ADDENDUM No. 2

Project: **Washtenaw - Addition**
Location: 7400 South Huron River Dr., Ypsilanti, MI, 48197
Contract No: Y21456 File No: 511/21326.CAK DMVA No: 26C8022016
A/E File #: 2105-01
Date: August 15th, 2022

PBA Project Name: GHF SOM DMVA Washtenaw Armory Reno
PBA Project Number: 2021.0363.00
Addendum Number: 02
Date: August 15, 2022

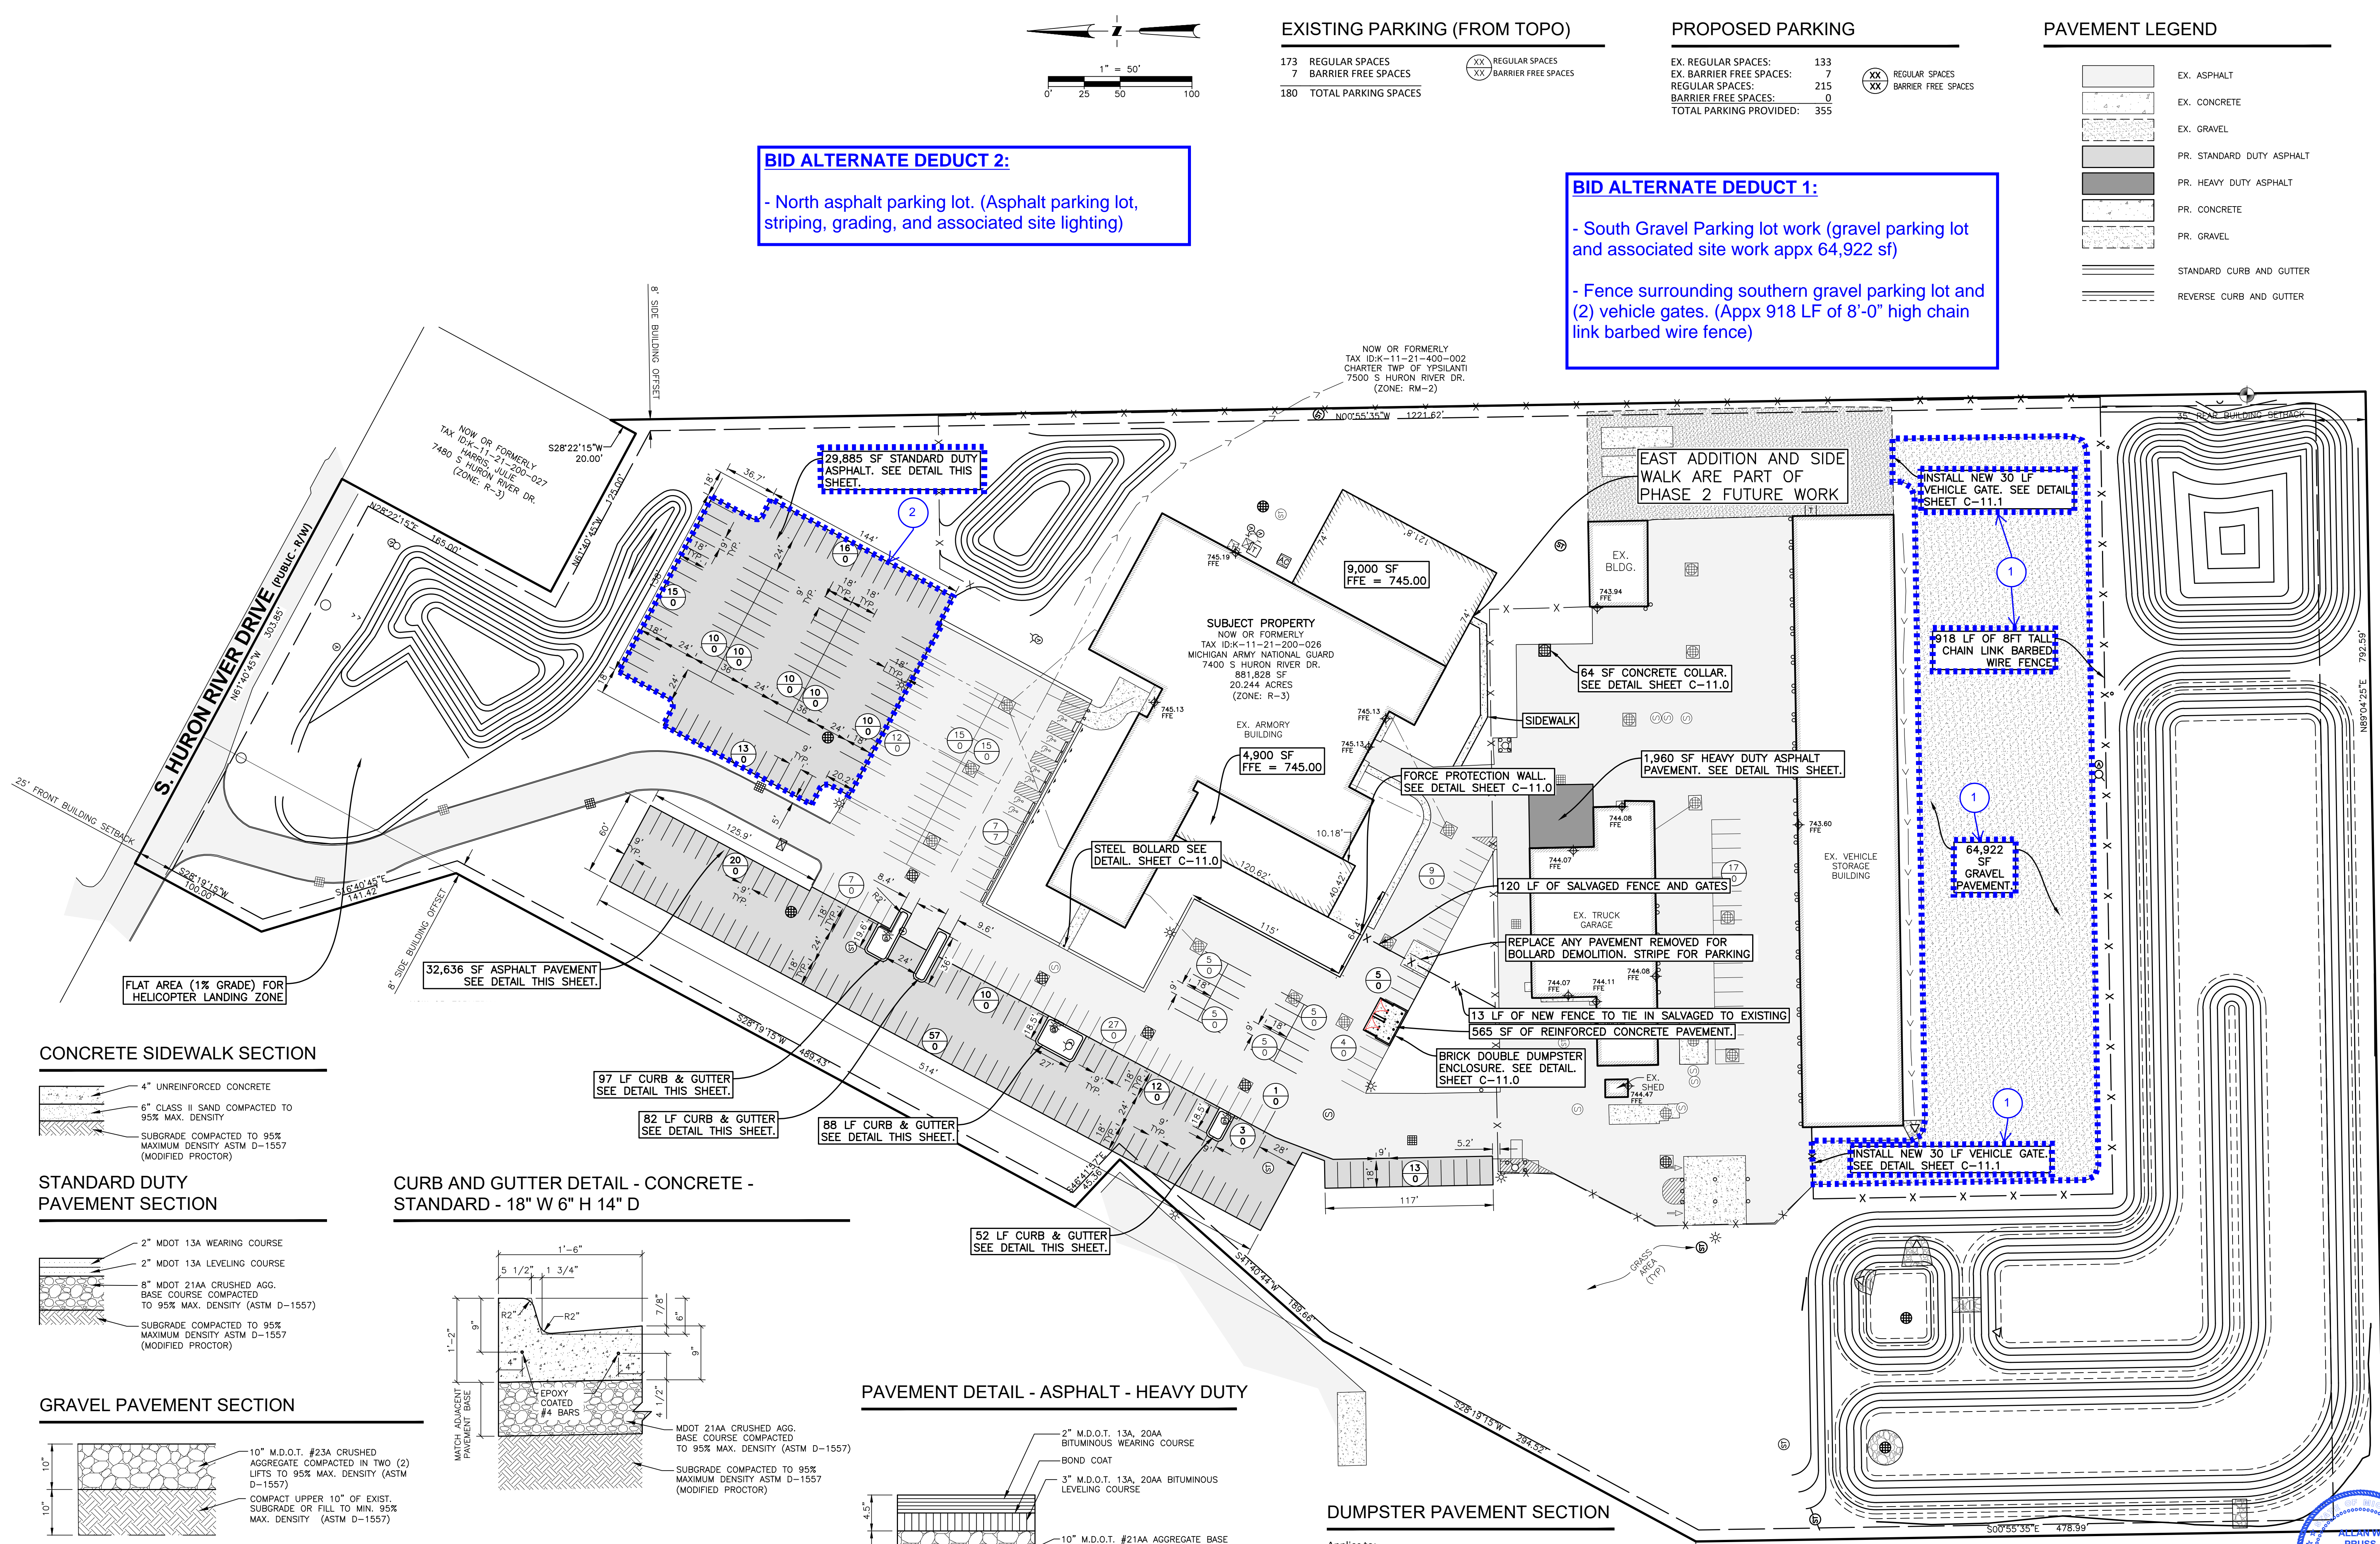
Item 1: Modify MICH Spec Section 00300 Bid Summary to include the below deductive alternates. Refer to enclosed Reissued MICH Spec Section 00300 and noted drawing C 1.0.

BID ALTERNATE DEDUCT 2:
 - North asphalt parking lot. (Asphalt parking lot, striping, grading, and associated site lighting)

BID ALTERNATE DEDUCT 1:
 - South Gravel Parking lot work (gravel parking lot and associated site work appx 64,922 sf)
 - Fence surrounding southern gravel parking lot and (2) vehicle gates. (Appx 918 LF of 8'-0" high chain link barbed wire fence)
